SUBJECT: SURRY UNITS 1 AND 2 - ISSUANCE OF AMENDMENTS RE: SERVICE  
WATER TEMPERATURE LIMIT (TAC NOS. M86944 AND M86945)

AMENDMENT NO. 183 TO FACILITY OPERATING LICENSE NO. DPR-32 - SURRY UNIT 1  
AMENDMENT NO. 183 TO FACILITY OPERATING LICENSE NO. DPR-37 - SURRY UNIT 2

SAFETY EVALUATION BY THE OFFICE OF NUCLEAR REACTOR REGULATION  
RELATED TO AMENDMENT NO. 183 TO FACILITY OPERATING LICENSE NO. DPR-32  
AND AMENDMENT NO. 183 TO FACILITY OPERATING LICENSE NO. DPR-37  
VIRGINIA ELECTRIC AND POWER COMPANY  
SURRY POWER STATION, UNIT NOS. 1 AND 2  
DOCKET NOS. 50-280 AND 50-281

**ALLOWABLE AIR PARTIAL PRESSURE  
SURRY POWER STATION UNITS 1 AND 2**

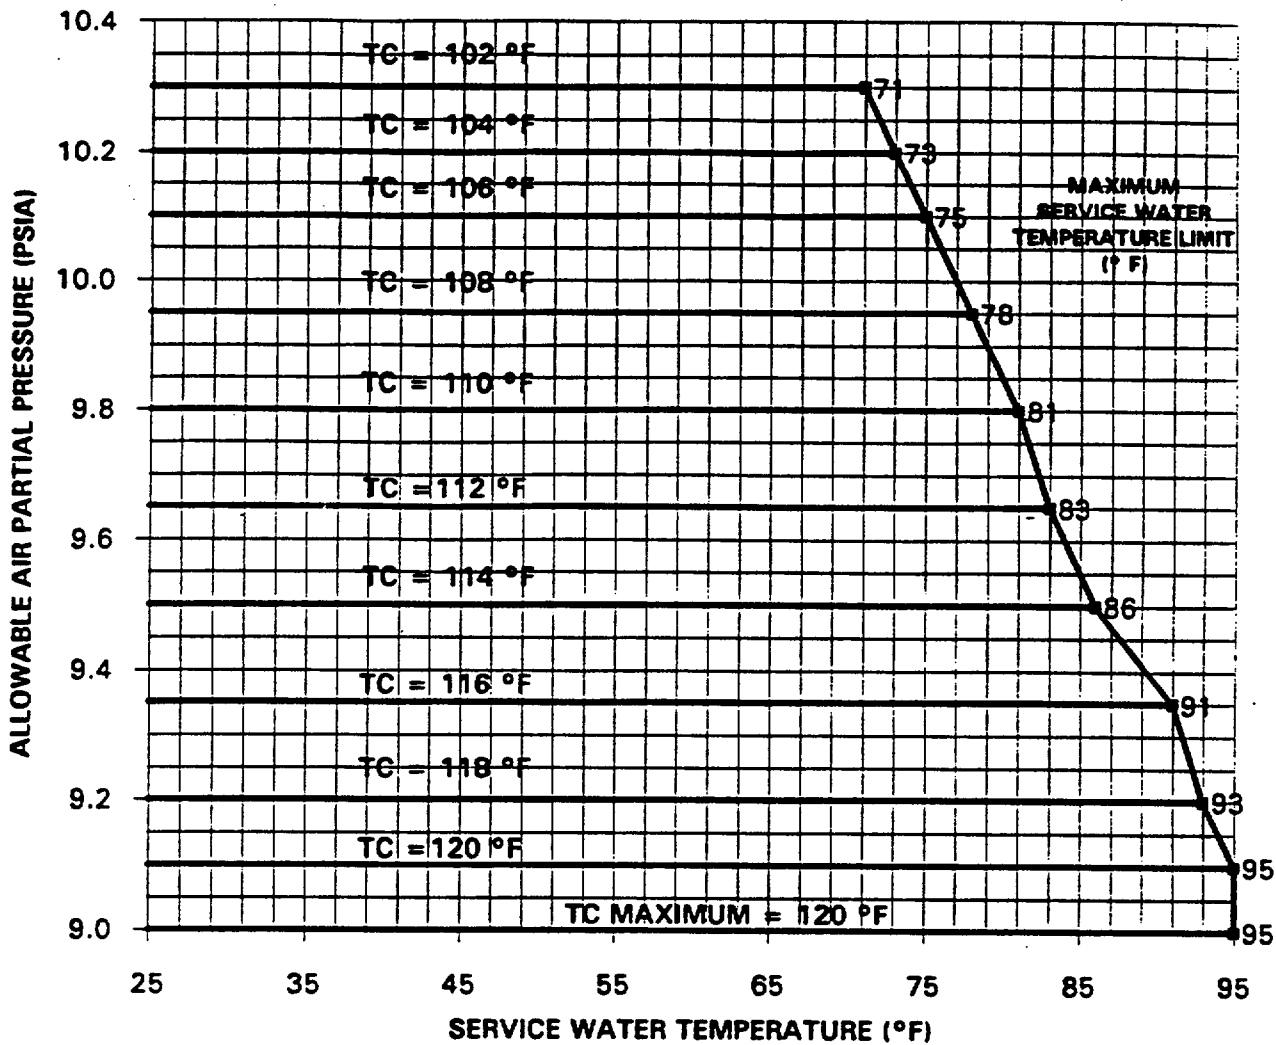
These amendments permit operation with a three degree increase in the service water temperature limit for containment air partial pressures of 9.1, 9.2 and 9.35 psia. Typographical errors made in previous amendments are also corrected.

TS Figure 3.8-1 is being revised to permit operation with a three degree increase in the service water temperature limit for containment air partial pressures of 9.1, 9.2, and 9.35 psia. The revised service water temperature limits for these partial pressures are 95°F, 93°F, and 91°F respectively. The curve on the figure is being revised to fit these points.

The licensee has performed containment response analysis at a three degree higher service water temperature for containment air partial pressures of 9.1, 9.2, and 9.35 psia. Models, methods, and input consistent with the current analysis of record were used for the analysis. The licensee used previously existing analysis margins to accommodate the impact of the three degree service water temperature shift. The results of the analysis indicate that the worst case values for the post loss-of-coolant accident containment response criteria are still bounded by the safety analysis. The response criteria are peak pressure, depressurization time, subatmospheric peak pressure and engineered safety features pump net positive suction head.

Since the analysis indicates that the containment will continue to meet its design basis acceptance criteria following a DBA, and since the analysis was performed with current models, methods and inputs, the staff finds the licensee's proposed revision to TS 3.8 acceptable.
